MODEL: 2016 Ninja® ZX™-10R/10R ABS**TITLE:** STEERING DAMPER BRACKET MOUNTING BOLTS

RECALL

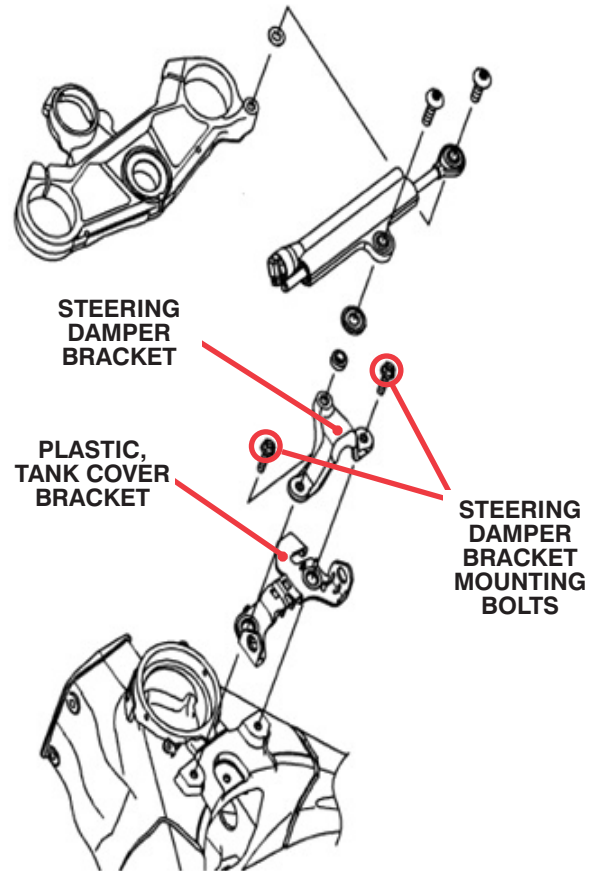
- Remove the fuel tank covers (three pieces) as outlined on pages 15-16 & 15-17 of service manual 99924-1509-01.
- Remove and discard the left steering damper bracket mounting bolt.
- Install the new left bolt finger tight only.
- Remove and discard the right steering damper bracket mounting bolt.
- Install the new right bolt finger tight only.

- o *Be careful not to pinch the plastic tank cover bracket between the frame and the steering damper bracket when installing and tightening the new bolts.*

- Tighten the right bolt to 71 in•lb (0.82 kgf•m, 8.0 N•m) while pressing down on the center of the steering damper bracket while moving the steering damper bracket from side to side.
- Tighten the left bolt to 71 in•lb (0.82 kgf•m, 8.0 N•m).
- Tighten the right bolt again to 71 in•lb (0.82 kgf•m, 8.0 N•m).
- Install the fuel tank covers (three pieces) as outlined on pages 15-17 & 15-18 of service manual 99924-1509-01.
- Install the seats.

Repair Verification

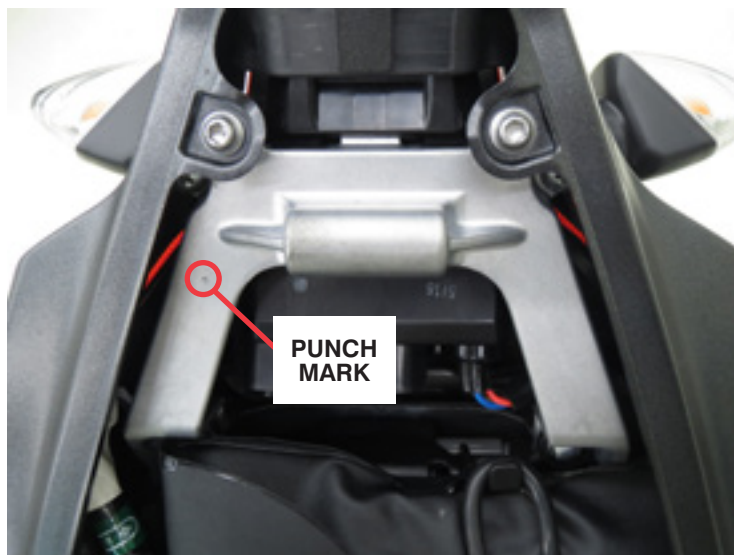
Make a punch mark on the right rear frame as shown for repair verification.
